SUBJECT: NRR SALP III ASSESSMENT FOR MIDLAND PLANT, UNITS 1 & 2

FACILITY NAME: Midland Nuclear Plant, Units 1 and 2

APPLICANT: Consumers Power Company  
FACILITY: Midland Plant, Units 1 and 2  
SUBJECT: SUMMARY OF AUGUST 25, 1980 MEETING ON LICENSING STATUS OF THE  
MIDLAND PLANT, UNITS 1 AND 2

SUBJECT: CORP OF ENGINEERS REPORT AND REQUEST FOR ADDITIONAL INFORMATION ON PLANT FILL

SK. 23  
Midland Plant Units 1 and 2  
Attachment 3 to  
Report on Cable Installat

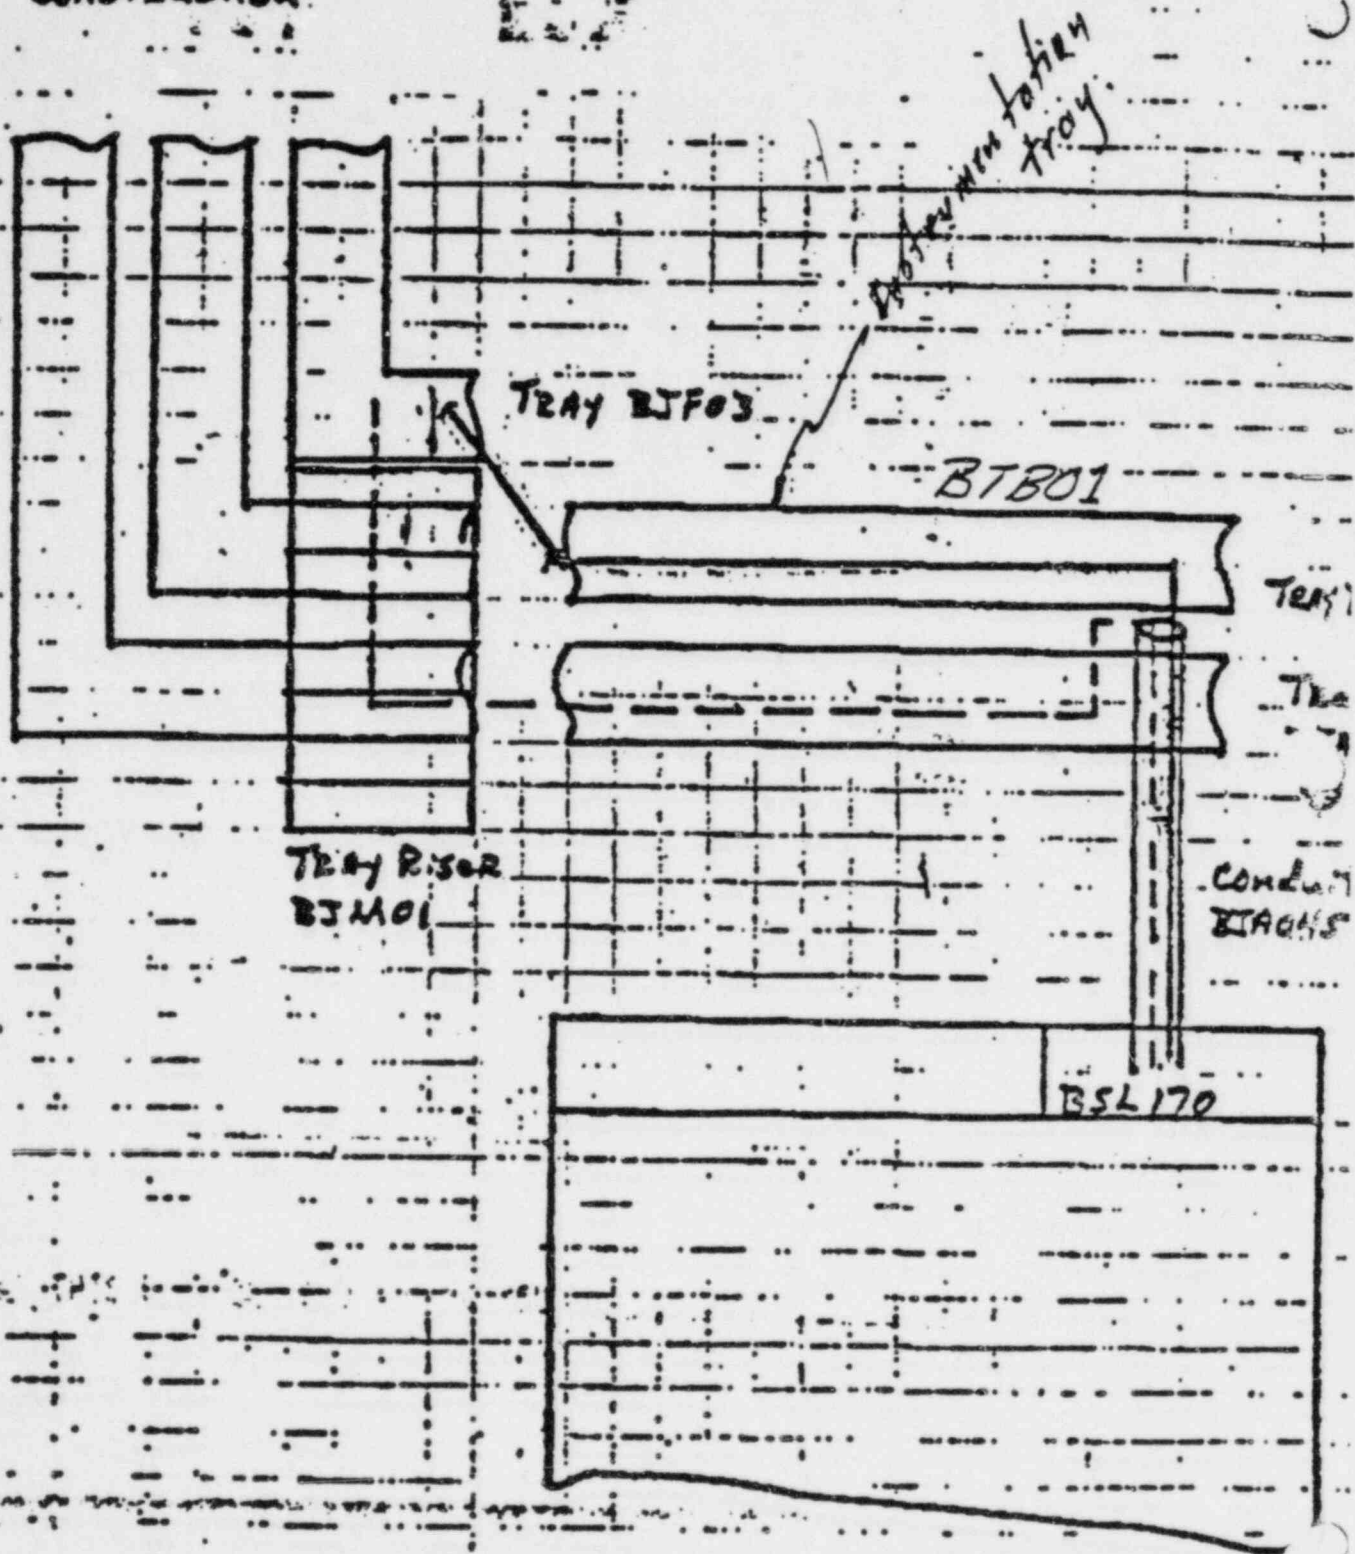
Cable was pulled into tray AFC07-09, not listed in E37 vias, without engineering's knowledge.

Accountability; i.e., not knowing where a cable is pulled. This problem may have an adverse affect on thermal analysis.

When a tray is wrapped, heat generated from cables in the tray must be taken into consideration. If a cable were pulled into that tray and engineering was not aware of it, the thermal analysis would not include that cable.

SK-25

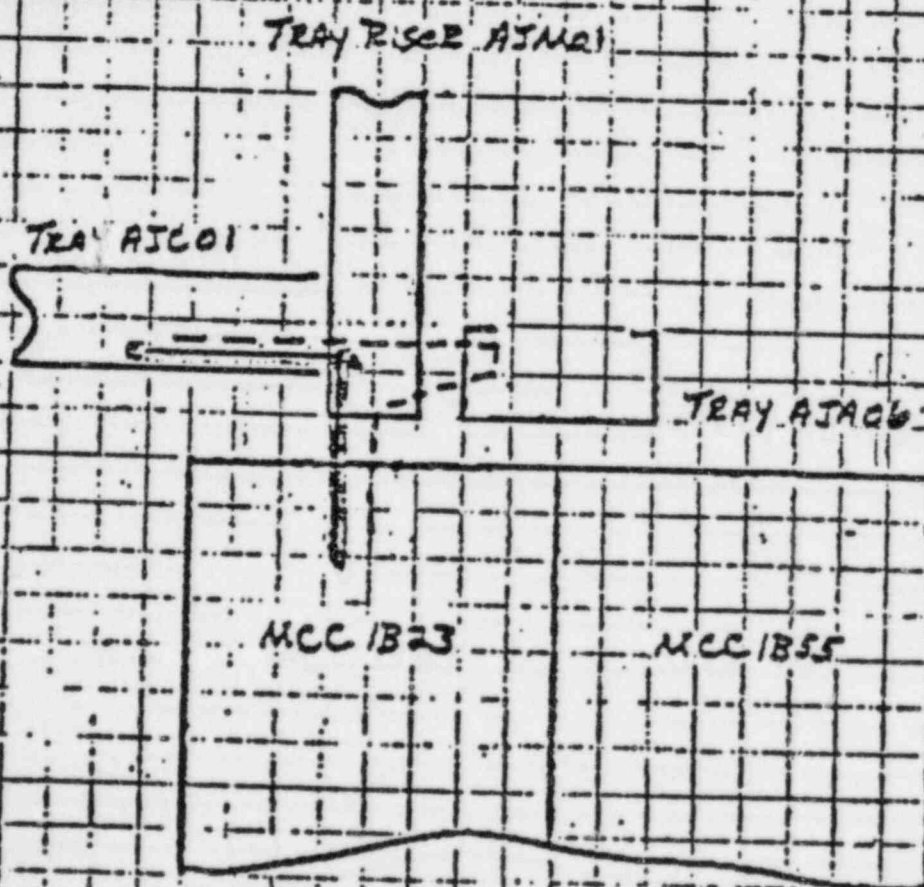
Sixteen small instrument cables were pulled into the wrong conduit.

There is ample room in conduit DTA002/DC003 for the additional cable. There are no thermal concerns. This was a unique case because the subject conduits and cables had undergone successive renumbering and relocation after initial installation 1) to accommodate neutron detector cables and 2) because a steel beam blocked access to some of the conduit sleeves. The many changes may have caused confusion which led to the misinstallation of the cables. It is not credible that this situation would be repeated elsewhere; therefore, it constitutes a unique case.
